UNITED STATES PATENT AND TRADEMARK OFFICE

Office Action Summary

10/568,812

DETAILED ACTION

Fig. 3

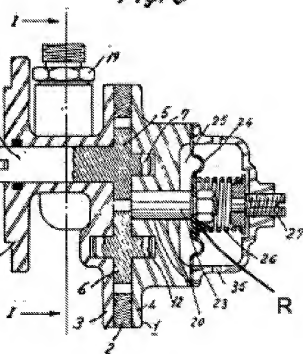
10. Nevertheless, Zenith, with reference to figure 3 below, describes a fluid pump with a pressure chamber (25) wherein the pressure prevailing in the pressure chamber (25) influences the force on the valve piston (23) in the closing direction in such a way that as the pressure in the pressure chamber (25) decreases, the force on the valve piston (23) in the closing direction increases. The advantage of this pressure chamber, as described by Zenith on page 1, line 34 is to "provide in a pump of this type an exact regulation of the pump delivery pressure".

13. Note further that the combination of AAPA/Zenith will inherently consist of **the valve piston being offset from a connecting line between the axes of rotation of the two delivery elements**. Fig.3 above clearly shows this because the axes of rotation of 5 and 6 extend left/right for a far length at least as far as the rotors themselves, but actually, an infinite distance. One can see above that at the far left portion of each rotor, 5 and 6, if a connecting line were to be made between those points, the piston valve would certainly be offset from that line.

14. In re claim 11, with reference to figure 3 above, Zenith discloses the pressure chamber (25) delimited by a moving wall (24), one side of which is acted on by the pressure prevailing in the pressure chamber (25) and the other side of which is acted on by a prestressed spring (26) that pushes the wall (24) toward the valve piston (23) in its closing direction.

15. In re claim 12, Zenith discloses the moving wall (24) supported against the valve piston (23) by means of a rod (R).

16. In re claims 13-14, with reference to figure 3 above, Zenith discloses the moving wall (24) is embodied in the form of a diaphragm.
17. In re claims 15-18, with reference to figures 2 and 3, Zenith discloses the valve piston (23) at least partially delimiting the pump chamber (13) in the direction of the rotation axis of the at least one delivery element (5, 6), wherein the closing spring (26) presses the valve piston (23) against the end surface of the at least one delivery element (5, 6) oriented toward it, which end surface functions as a valve seat, and wherein the pressure prevailing in the pressure chamber (25) acts on at least part of the end surface of the valve piston (23) oriented toward the at least one delivery element (5, 6).
